Reference: DR: MG DA2011/017

RE: DEVELOPMENT APPLICATION 2011/017 – WALGETT POLICE STATION

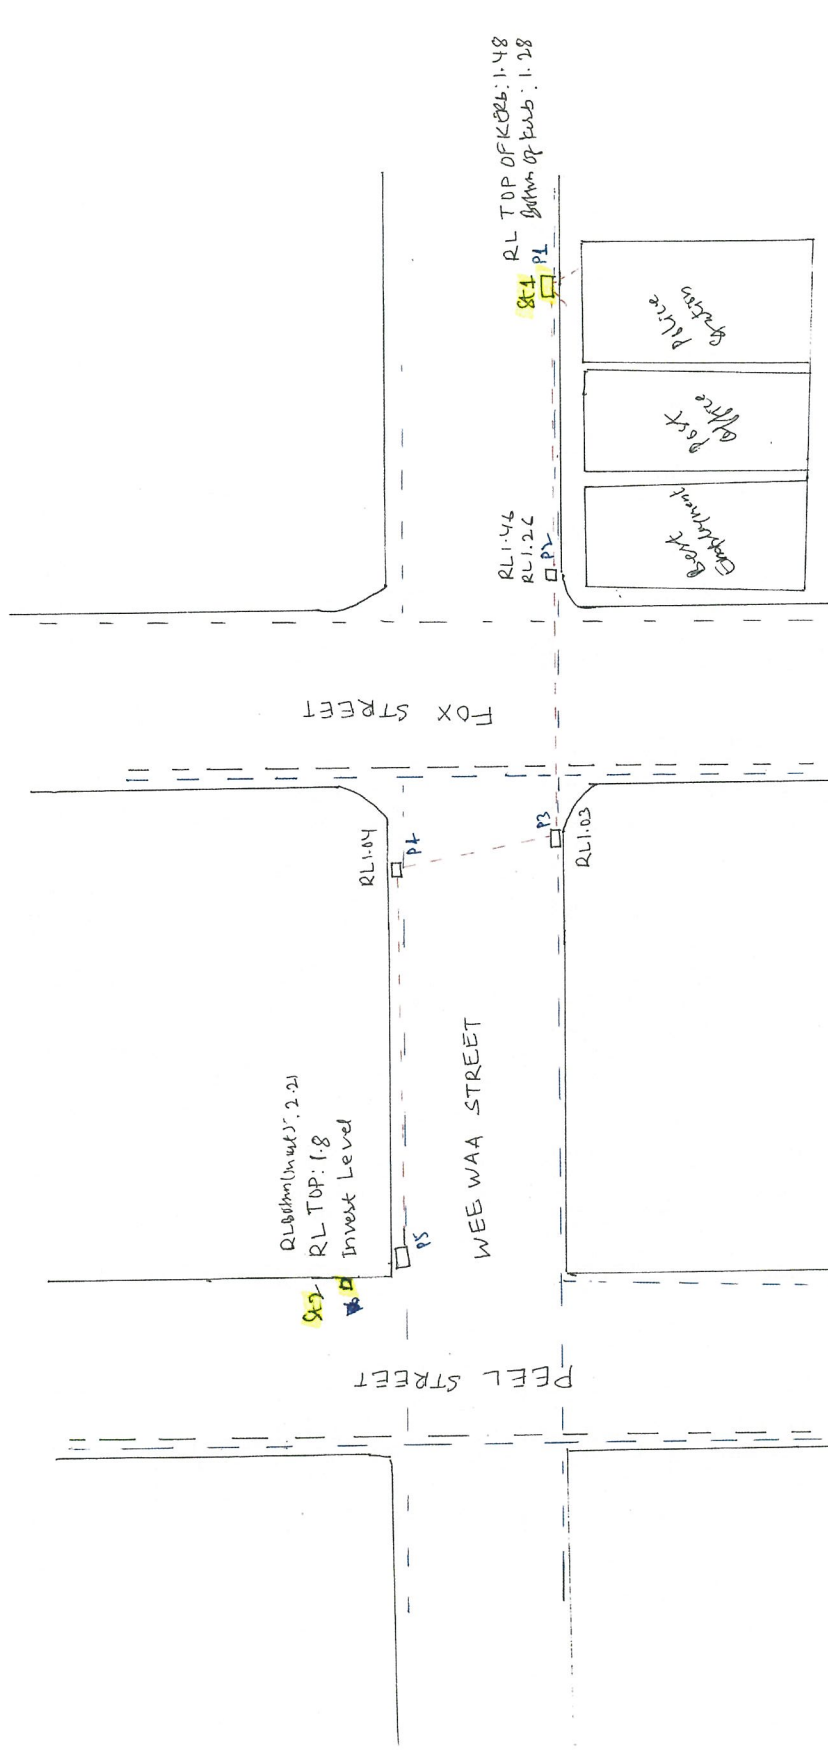
Proposed condition Plu 220 – UGL is not prepared to accept the proposed stormwater outlet restriction of a single 100mm diameter outlet. It has maintained that a 225mm outlet is required. As noted in Council's Development Application assessment report (page 11), having a stormwater outlet of this diameter directly into Wee Waa St is likely to exacerbate existing stormwater drainage problems in the vicinity.

- (a) There is a single 225mm diameter stormwater pipe outlet directly plumbed into a stormwater drainage pit adjoining the site.*
- (b) A 600mm underground stormwater drainage pipe is constructed from the stormwater drainage pit to Council's existing stormwater drainage infrastructure at the corner of Peel and Wee Waa Streets, in accordance with the attached concept diagram.*

- ① Take RL & Invert Level on St1 & St2
- ② Take Levels @ 10m intervals (follow the SWP notes)
- ③ Total Distance from St1 to St2.
- ④ Measurement of water mains - distance from kerb, & depth
- ⑤ What is the level difference
- ⑥ How far is proposed stormwater discharge pipe from proposed pit.

That the developer establishes stormwater drainage for the site so that the following outcomes are achieved:

- (c) Prior to the commencement of works, the developer must prepare a suitable design and obtain:*
 - *Approval from NSW Roads & Maritime Services for works that may affect Fox St (Castlereagh Highway) and Wee Waa St (part Kamilaroi Highway).*

- *Agreement from Walgett Shire Council's Director of Urban Infrastructure that the design is compliant with Council's specifications.*
- (d) Works are to comply with Walgett Shire Council specifications:*
